REQUEST

Current Zoning: R-3 (single family residential)
Proposed Zoning: UR-2(CD) (urban residential, conditional)

Approximately 5.12 acres located on the southeast side of Carmel Rd, north of Carmel Vista Ln. and south of Quail View Rd.

PLANNING STAFF REVIEW

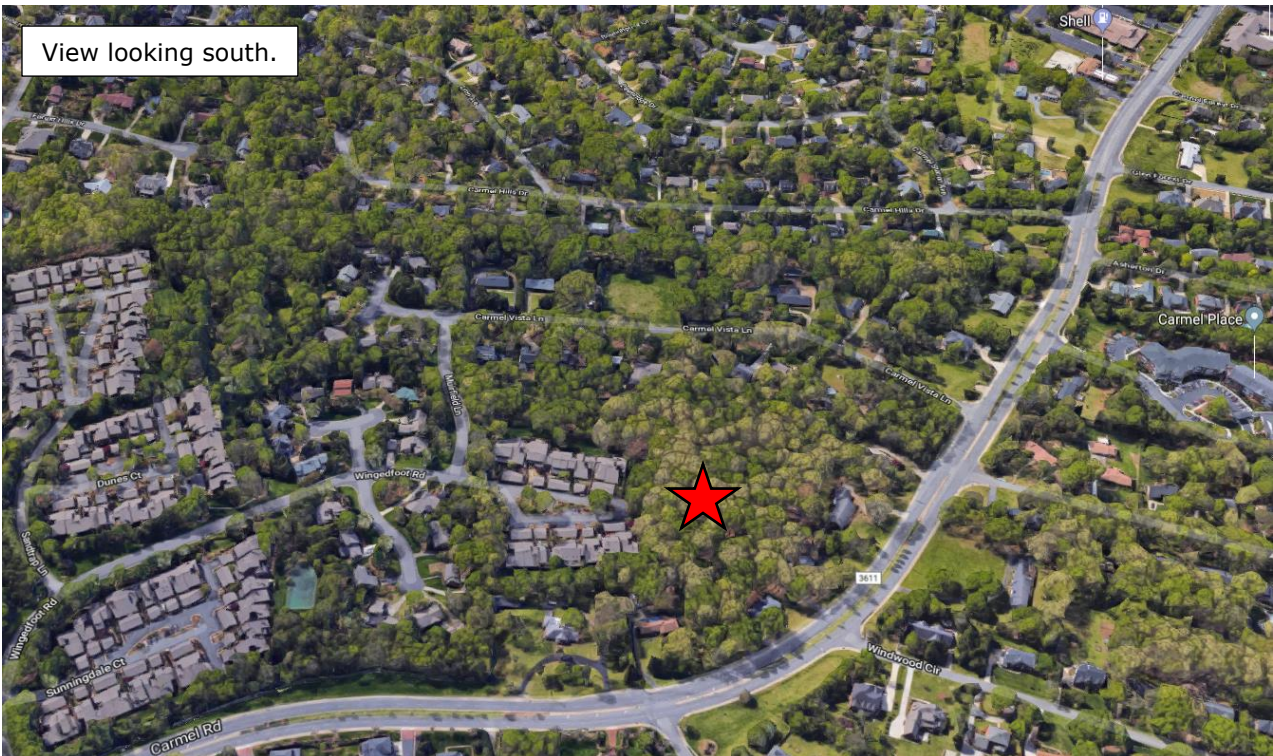
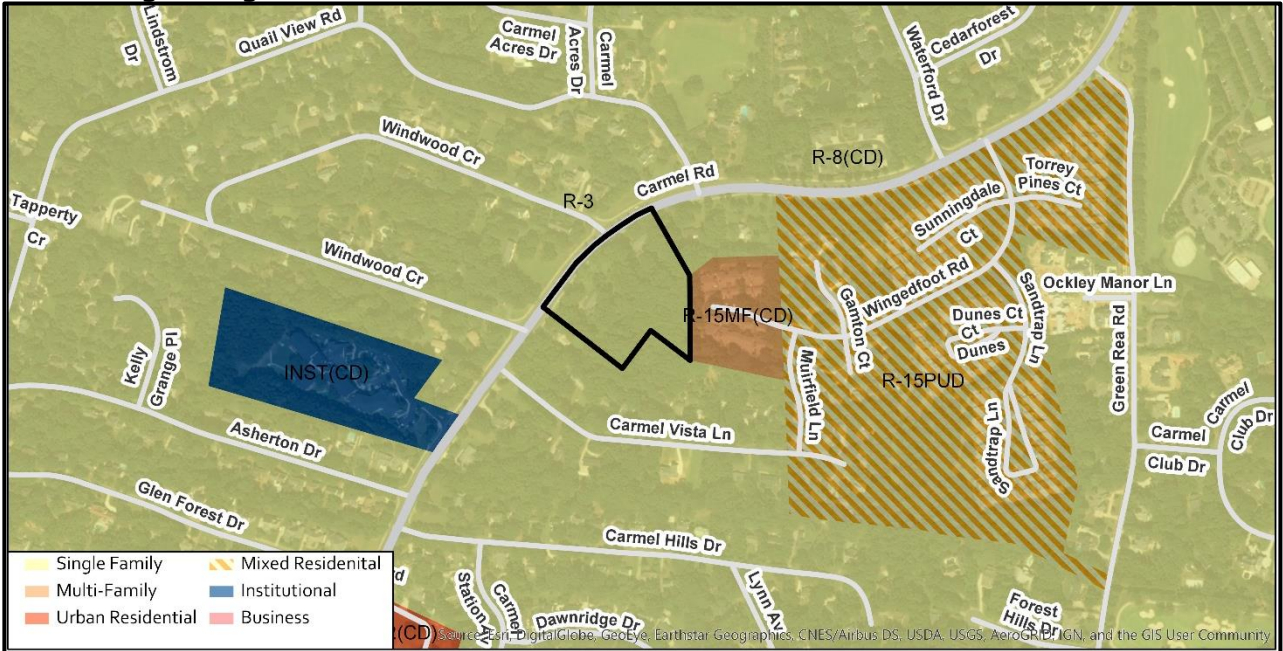
1. ~~Provide a minimum distance between the proposed building 4 and the property line.~~ Addressed

2. ~~Specify that the dedication of ROW, planting strip and sidewalk shall be completed prior to the first certificate of occupancy for the first new building on the site.~~ Addressed

3. ~~Remove reference to "wall pack" lighting in notes.~~ Addressed

4. ~~Under note "a" of Environmental Features revise Post Construction Controls Ordinance to read Post Construction Stormwater Ordinance.~~ Addressed
5. ~~Add the following note under the ENVIRONMENTAL FEATURES heading: "For adjoining parcels receiving storm water discharge from the site, the petitioner shall analyze the adequacy of the existing storm water conveyance on the adjoining parcels to and including Carmel Vista Lane. If the existing storm water conveyance on the adjoining parcels is found to be inadequate, the Petitioner shall make a good faith effort with the property owner(s) to improve the storm water conveyance or mitigate the storm water discharge onto the adjoining parcels."~~ Addressed
